SOUNDTRANSIT

ST3 COST ESTIMATE & GENERAL ASSESSMENT SERVICES

TASK 1: Draft Report of Significant Findings and Recommendations

REVISED APPENDIX A

Ecology Figure 1

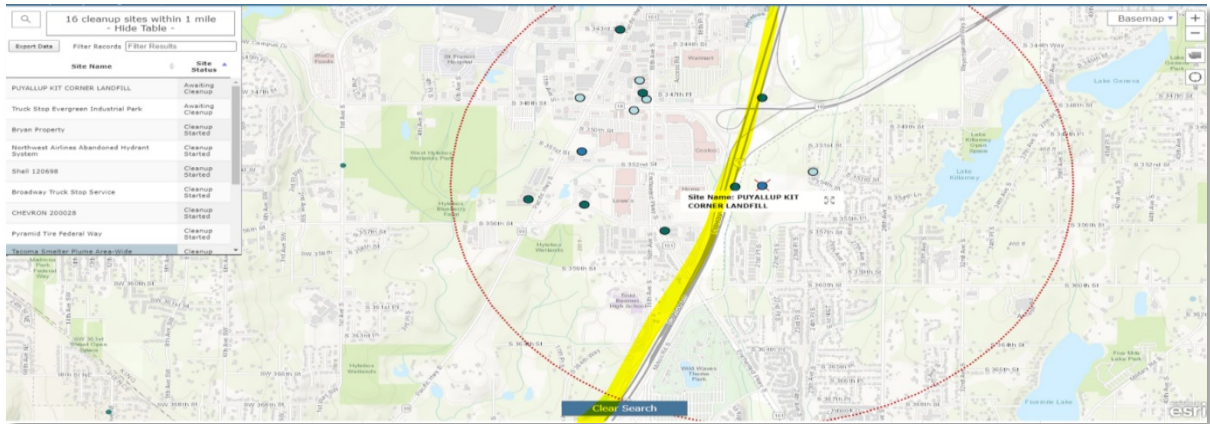
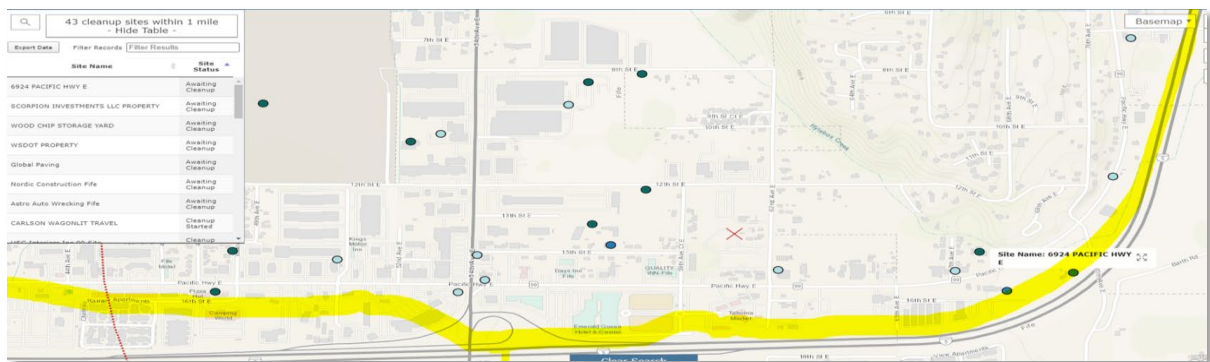
- Minimum effects to Hylebos Creek and Wapato Creek – preserving wetlands, trees, and vegetation.
- Minimum archaeological affect near Puyallup River for the Puyallup Tribe of Indians – cultural and human remains due to alignment type change

Ecology Figure 4

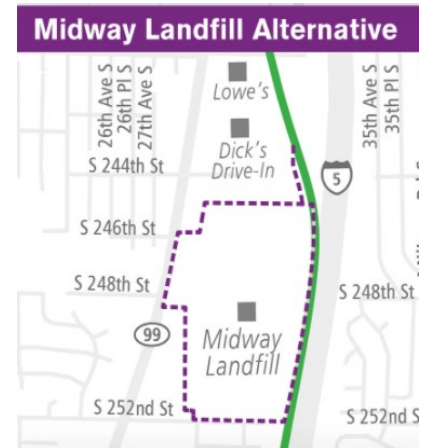
- New item of \$236,600 was added for wastewater management to treat and dispose of the contaminated surface water. The assumption is this will be used for dust control during construction.
 - » Assuming 6 x 750 GPM Mobile Treatment Solutions at \$35,000 = \$210,000
 - » Assuming 2 x Dissolving Tank at \$20,000 = \$40,000
 - » Assuming temporary piping and connections at \$25,000
- New item of \$260,000 was added for Erosion and Sediment Control which seems adequate.
 - » 52 acres of GeoNet, 3:1 slope at \$0.50 per SF = \$302,016

- New item of \$33.8M was added for Final Capping System for complete replacement of liner and landfill gas collection system. It seems to be high, but it may cover for unknowns/risks since it is a landfill.

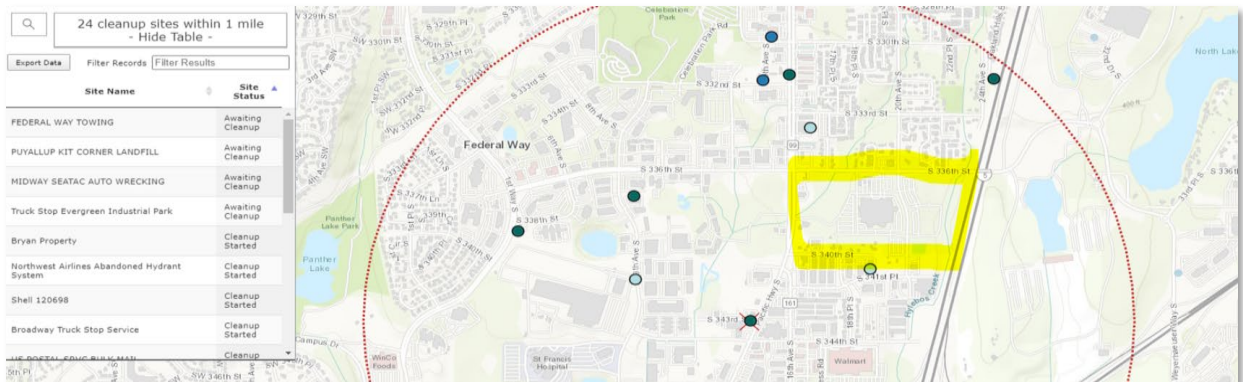
- Does WSDOT has wetland/mitigation bank in the neighborhood that can be used?
